Product Alert Notification (PAN)

Subject: Product Marking change
Publication Date: 4/25/2025
Effective Date: 5/19/2025

DA16200MOD-AAC

As IS

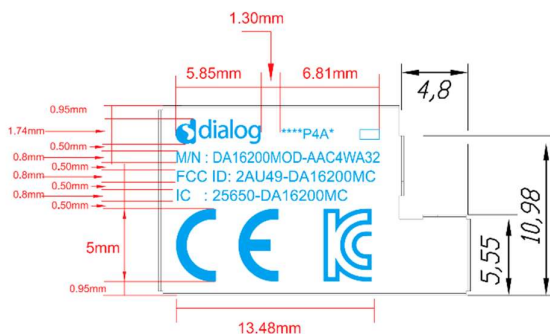
Description of Change:
Renesas is changing the log on the shield-can because of ANATEL certification.

TO BE

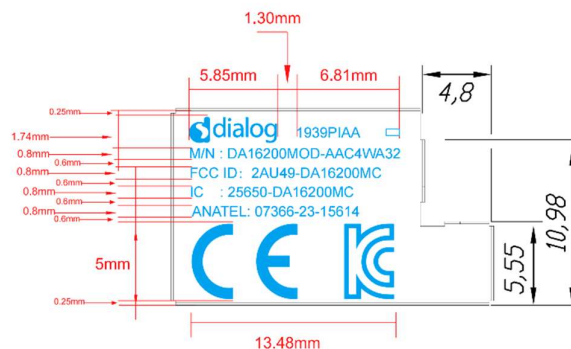
Impact on Fit, Form, Function, Quality & Reliability: The change will have no impact on the fit, function, quality, reliability, and environmental compliance of the products. However, the form in specific the marking appearance is changed as shown in the above images.
